MARICOPA COUNTY
Department of Transportation

MEMORANDUM

Case 13-01 A

Date: January 15, 2013
To: MAG Specifications and Details Committee
From: Robert Herz, MCDOT Representative
Subject: Correction to Detail 501-5

DETAIL NO. 501-5	STANDARD DETAIL ENGLISH	HEADWALL DROP INLET	REVISED 01-01-1998	DETAIL NO. 501-5
----------------------------	----------------------------	----------------------------	-----------------------	----------------------------

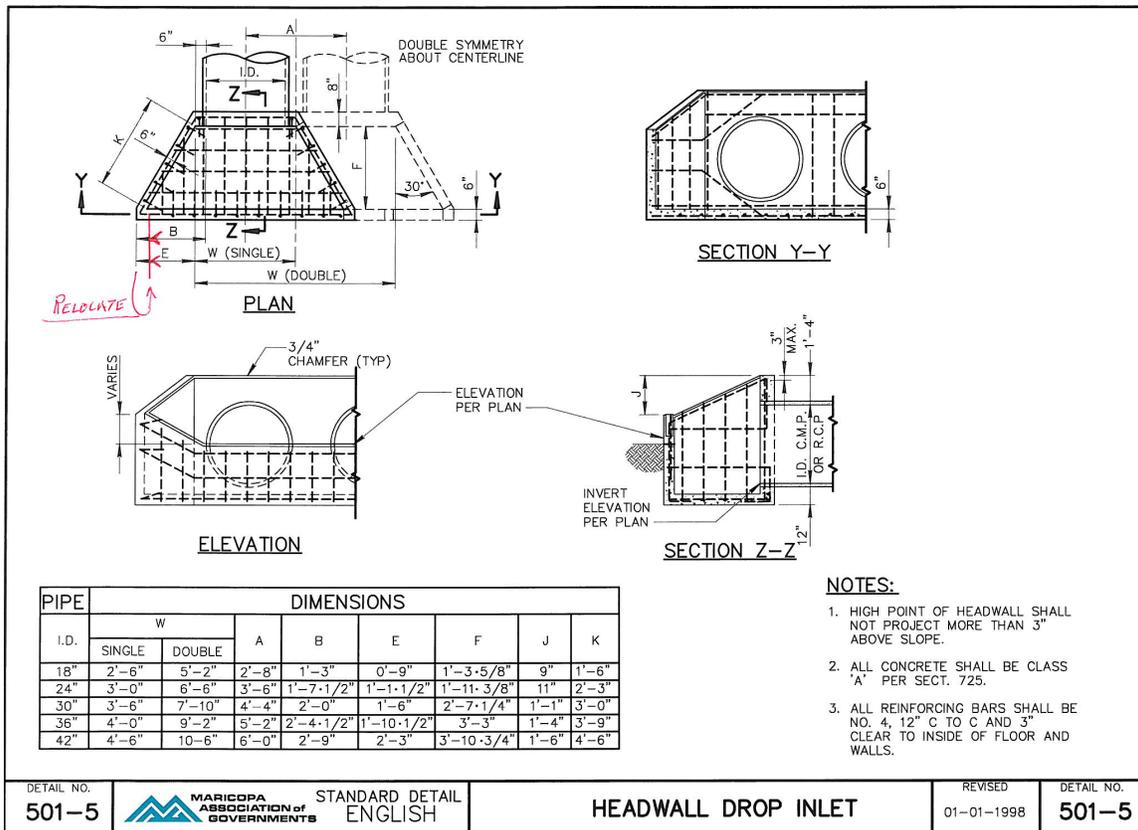
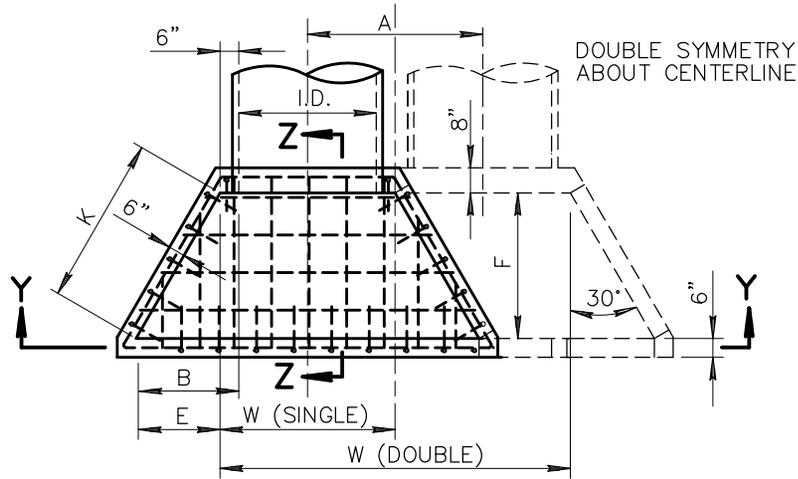
PURPOSE: Correct depicted distance B and E shown on PLAN view of Detail 501-5.

Variable distance B and E shown on the PLAN view are presently shown to the outside edge of the inlet basin wall, they should be shown to the inside edge of the inlet basin wall.
 (Distances E and F are the legs of a right triangle with hypotenuse K.)

DETAIL NO.
391-1

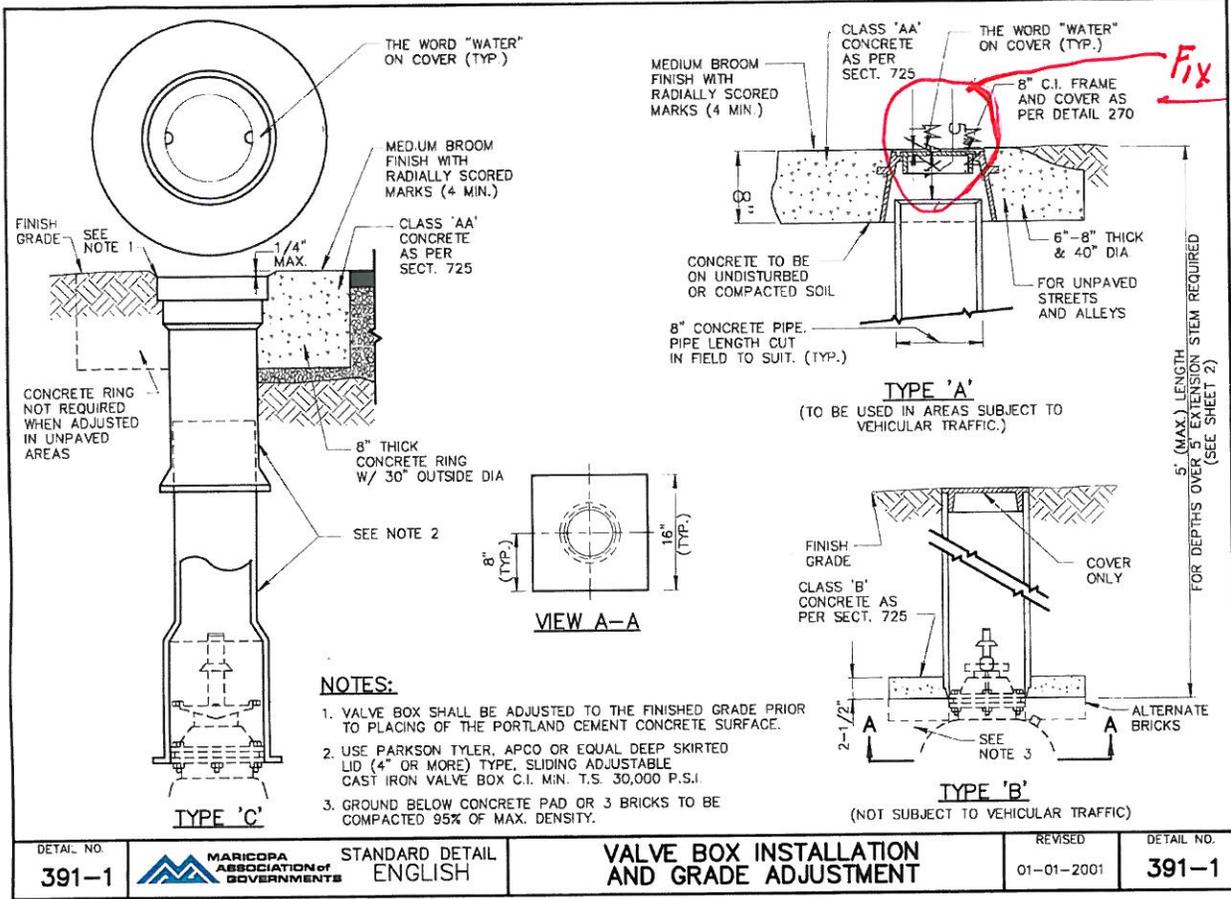
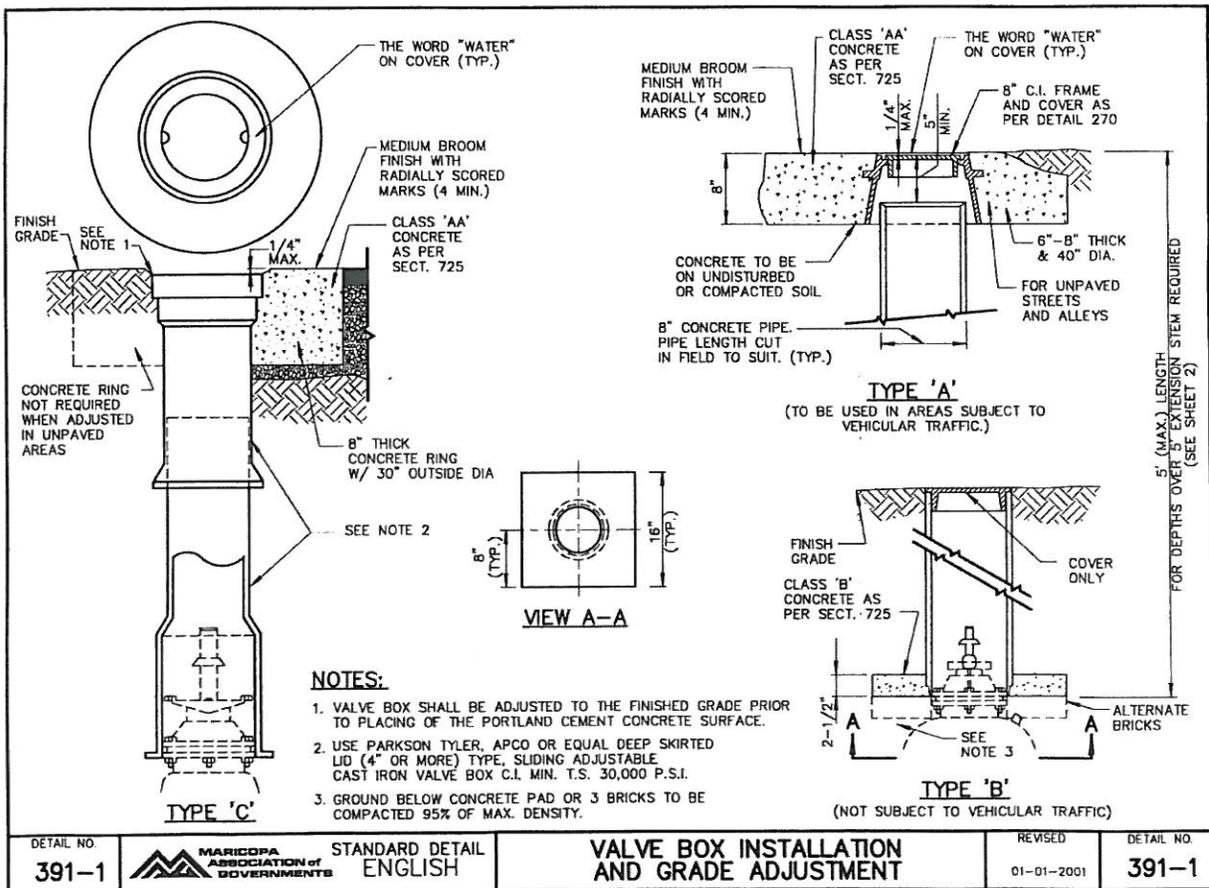
DETAIL IN 2013

DETAIL IN 2011
